# STATE OF OHIO DEPARTMENT OF TRANSPORTATION

## DEF-24-11.35

CONSTRUCT A NEW 0.42 MILE 2-LANE OVERPASS AT THE US24/CR 185 AT-GRADE INTERSECTION & REMOVE CURRENT INTERSECTION. THE PROJECT CONSISTS OF RAISING CR 185 OVER US24 ON THE EXISTING ALIGNMENT, CONSTRUCTING A NEW 2-SPAN BRIDGE & REMOVING INTERSECTION PAVEMENT ON US 24 & RESTORING US 24 TO A 4-LANE DIVIDED FACILITY.

ADDENDUM	NUMBER	DATE	DESCRIPTION
	1	02/14/2025	UPDATED DATE

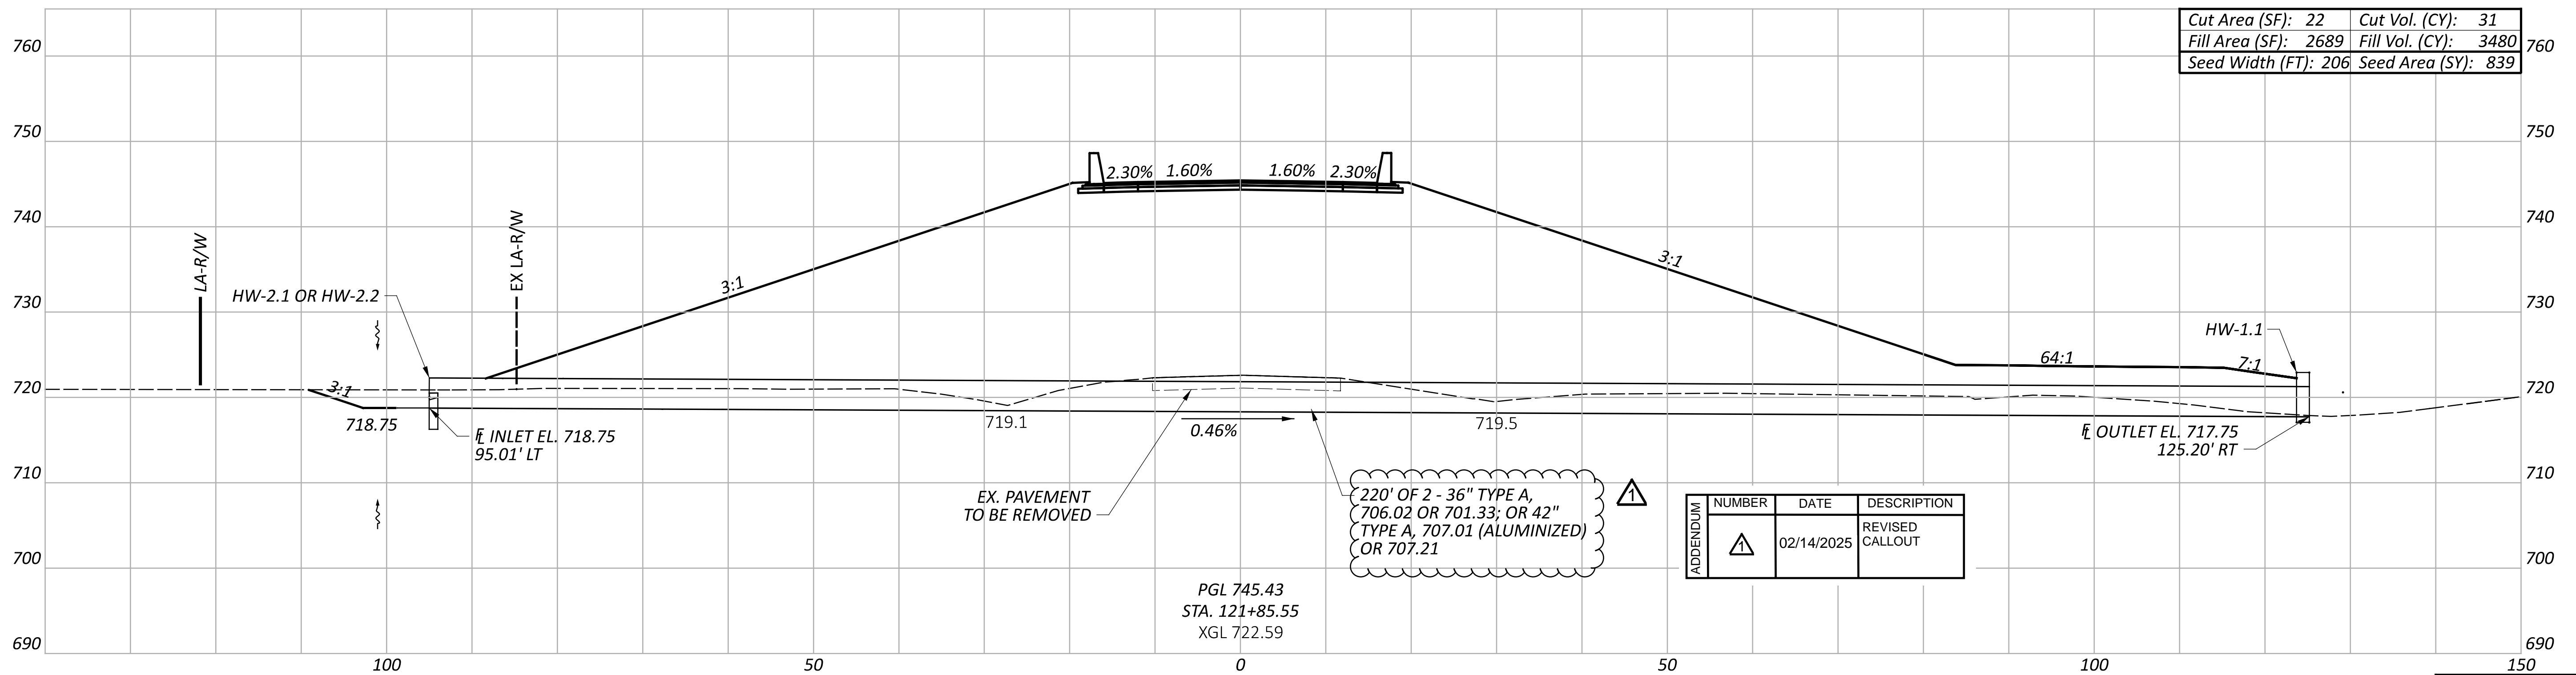
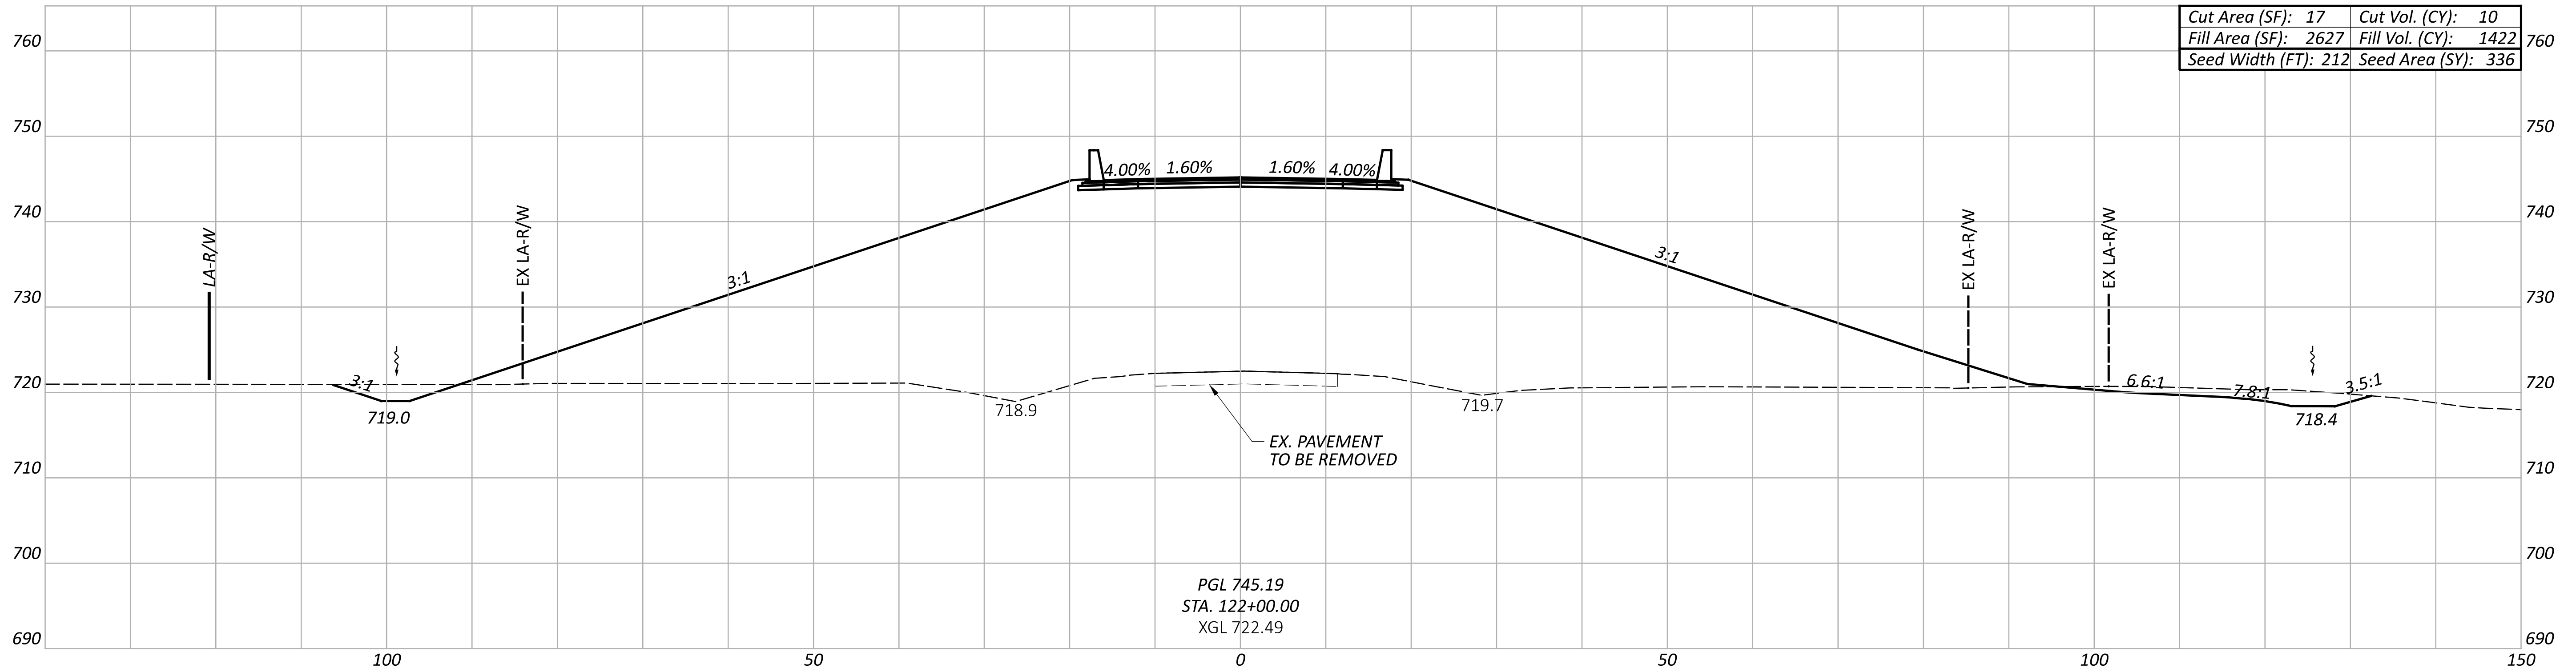
220' OF 2 - 36" TYPE A,  
 706.02 OR 701.33; OR 42"  
 TYPE A, 707.01 (ALUMINIZED)  
 OR 707.21

APPENDIX	NUMBER	DATE	DESCRIPTION
▲		02/14/2025	REVISED CALLOUT

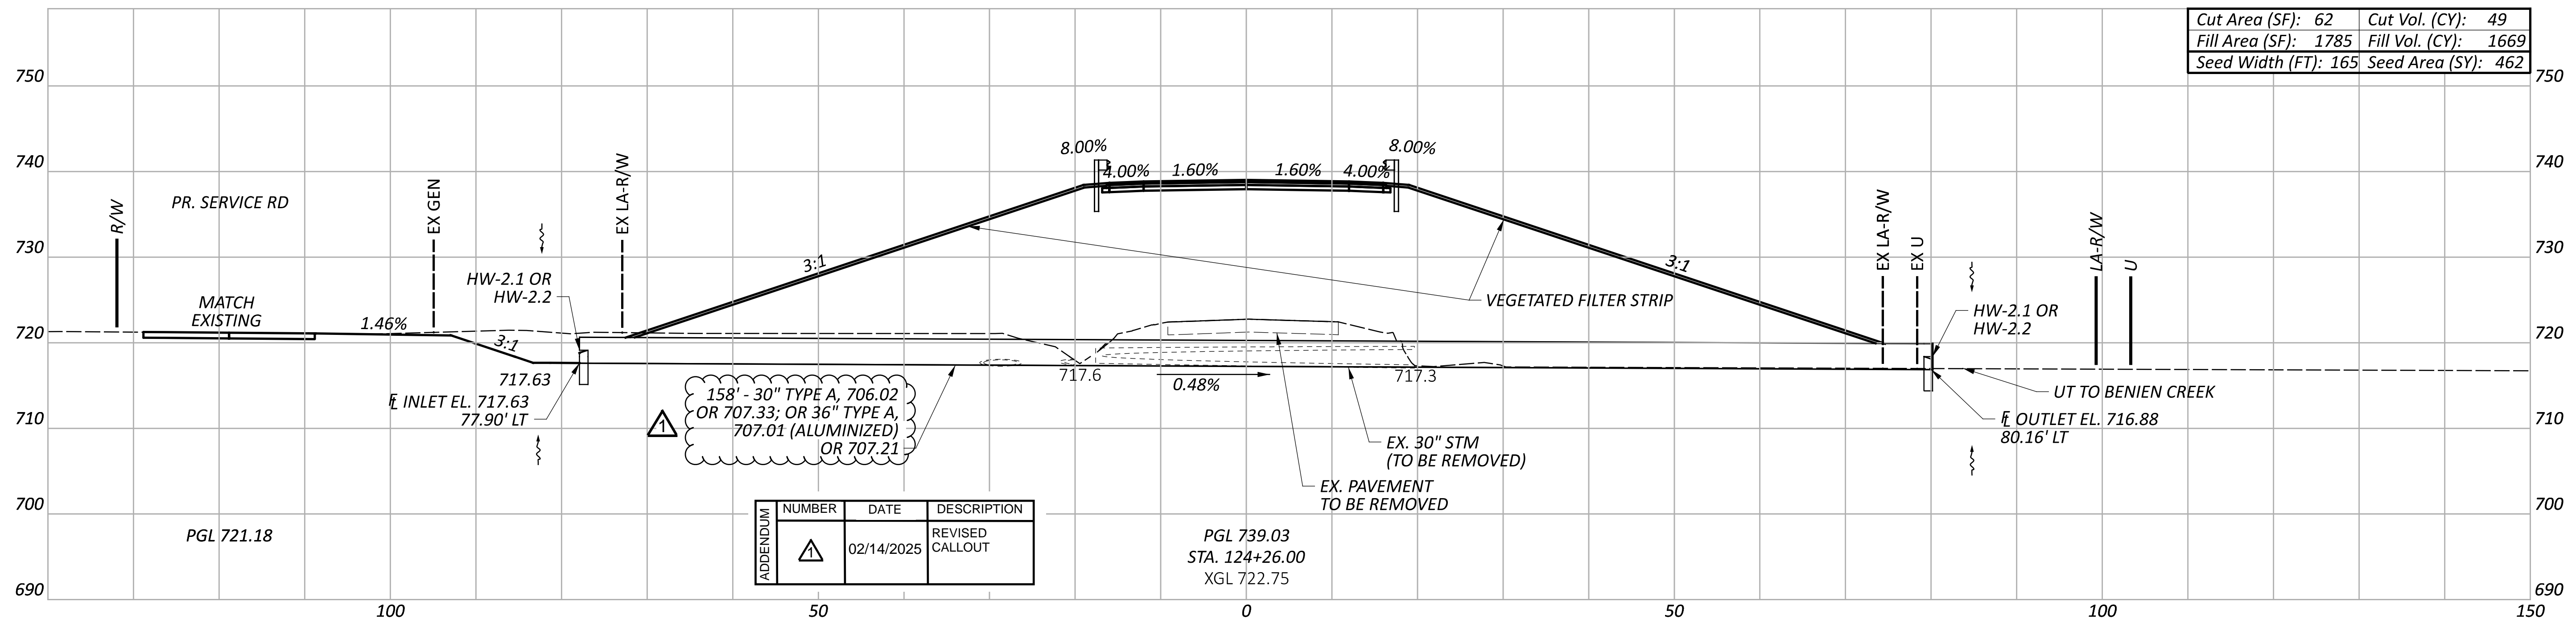
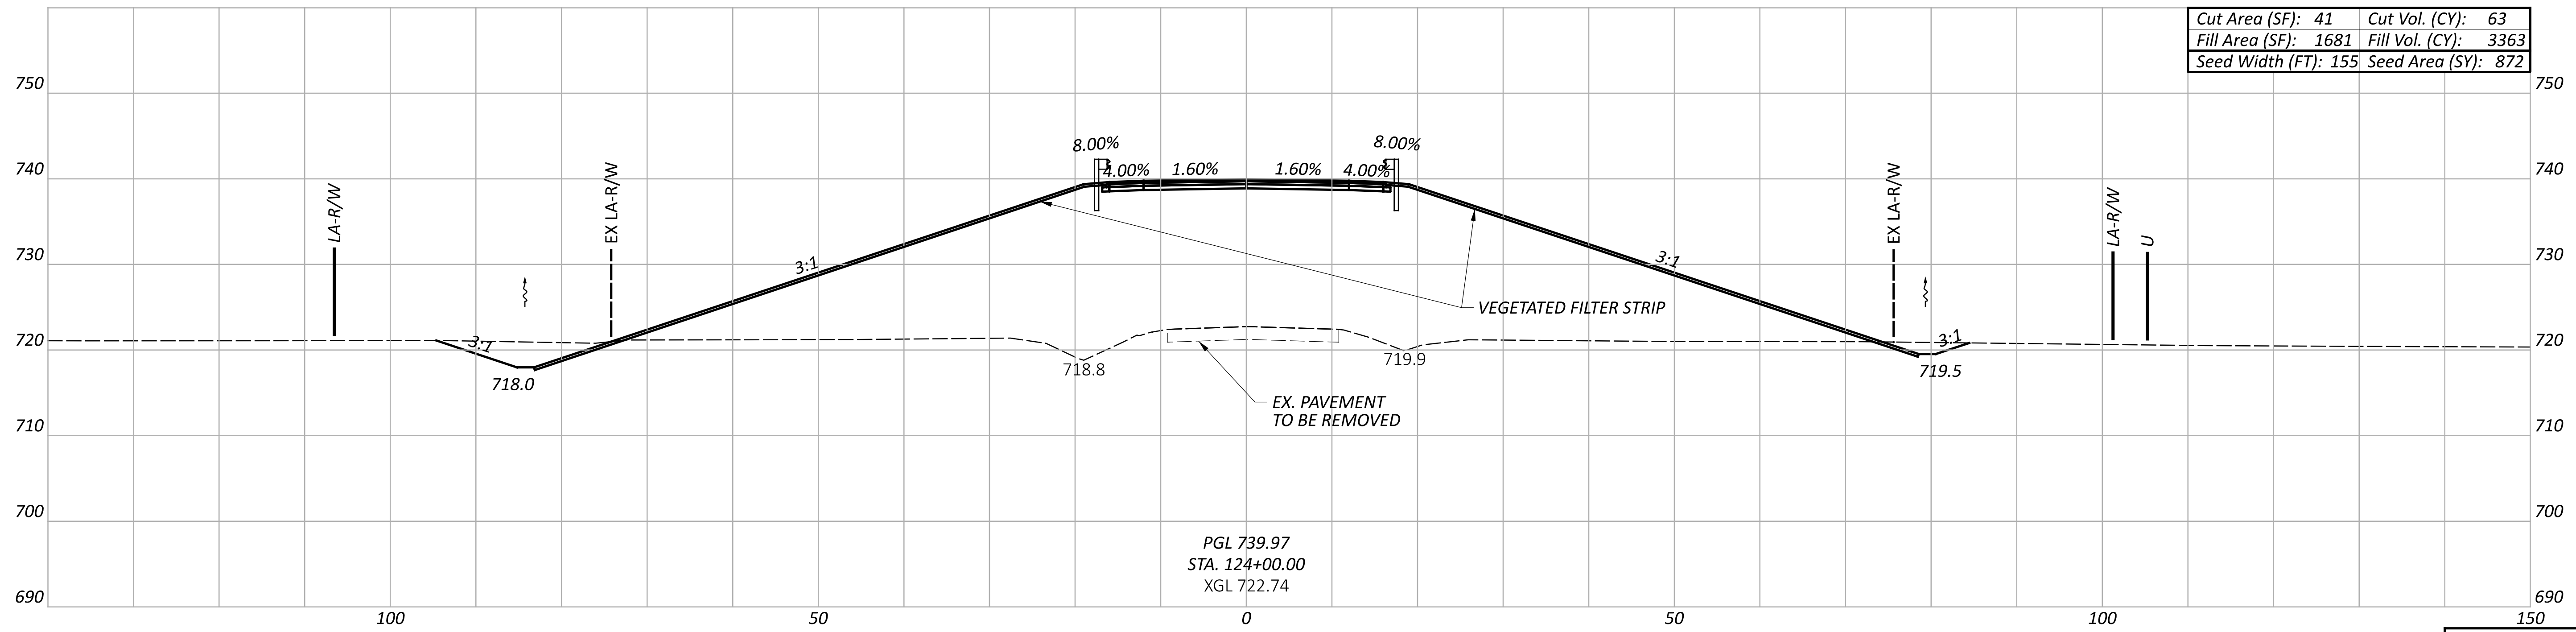
APPENDIX	NUMBER	DATE	DESCRIPTION
▲	02/14/2025	REVISED	CALLOUT
